## ADDENDUM NUMBER ONE (1)

**DATE:** October 9, 2012

**RE:** BID NO. 2013-05 – Shoot House facility Building

**OWNER:** CITY OF EDINBURG

THE CITY OF <b>EDINBURG</b> Department of Public Works		
POLICE DEPT. SHOOT HOUSE		
SCALE VERT. HORIZ.	SHEET 19 OF 22	
PROJECT NAME	FILE NAME	SHEET NO.
SHOOT HOUSE	--	A5.1
DEPARTMENT	MONTH	YEAR
ENGINEERING	AUG.	2012

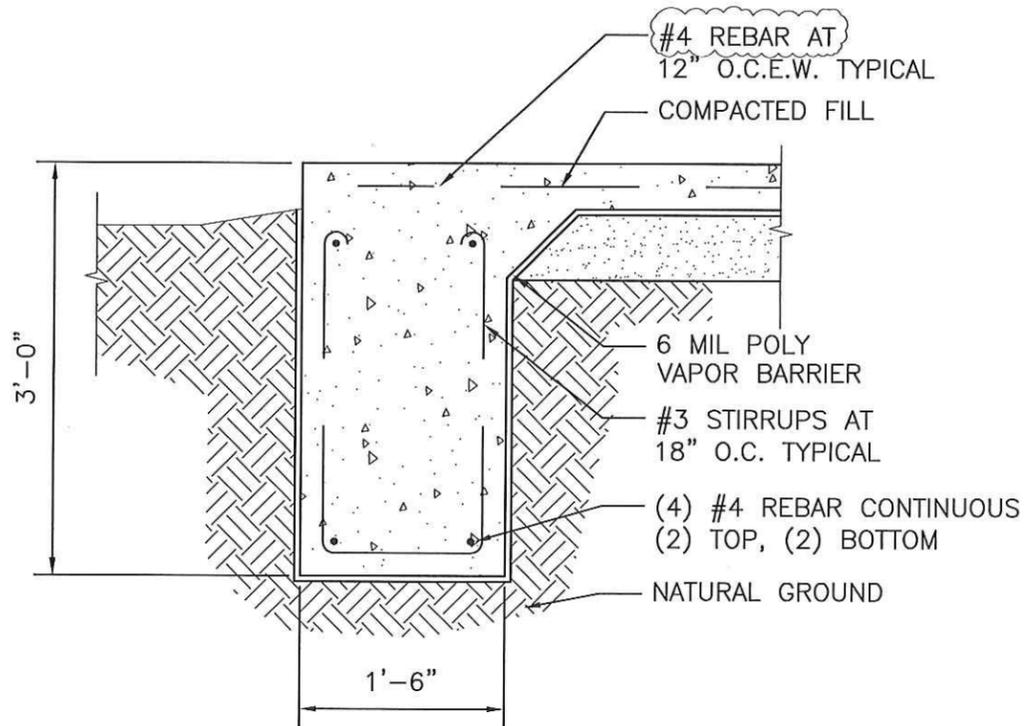
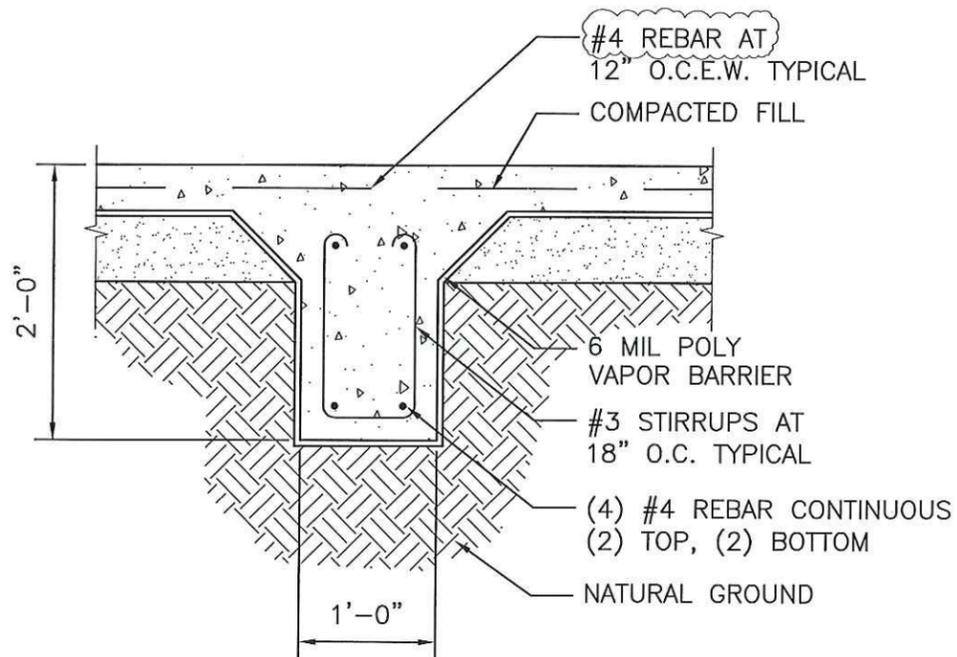
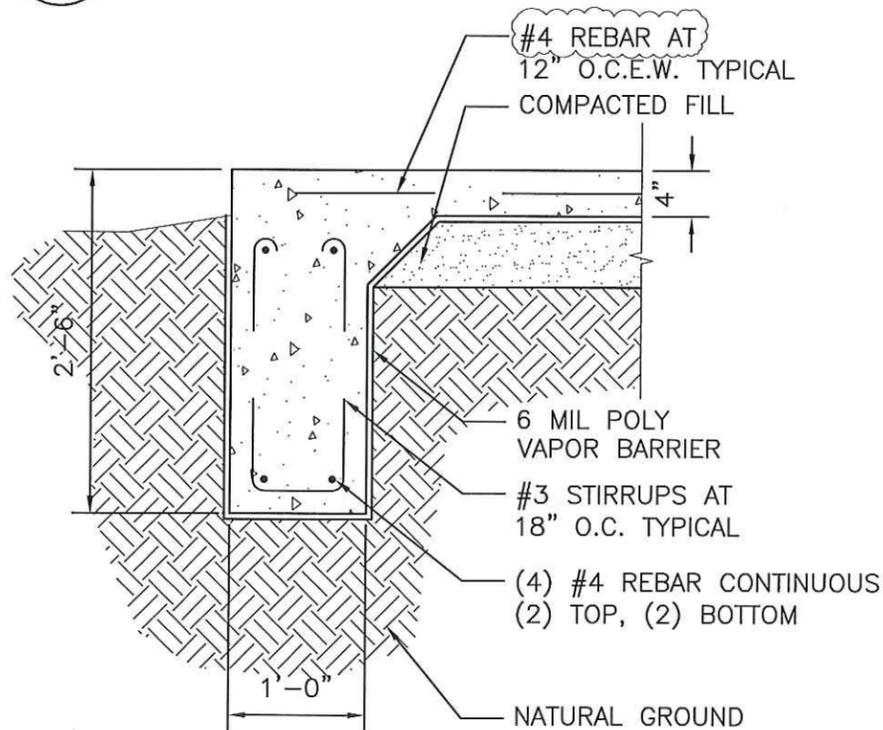
2. Revised Sheet 18 of 22 A5.1 and Sheet 19 of 22 A5.1 **ALT Foundation Note #3** – Updating note, removing 4½" Thick Slab and replacing with 4" Thick Slab and removing #3 rebar and replacing with #4 rebar.

6. Revised Sheet 18 & 19 of 22 **Foundation Notes #4** – updating notes adding use #4 24" X 24".
7. Revised Sheet 12 & 13 of 22 **Wall Section Details 1 & 2** – Adding weep post to each wall section.
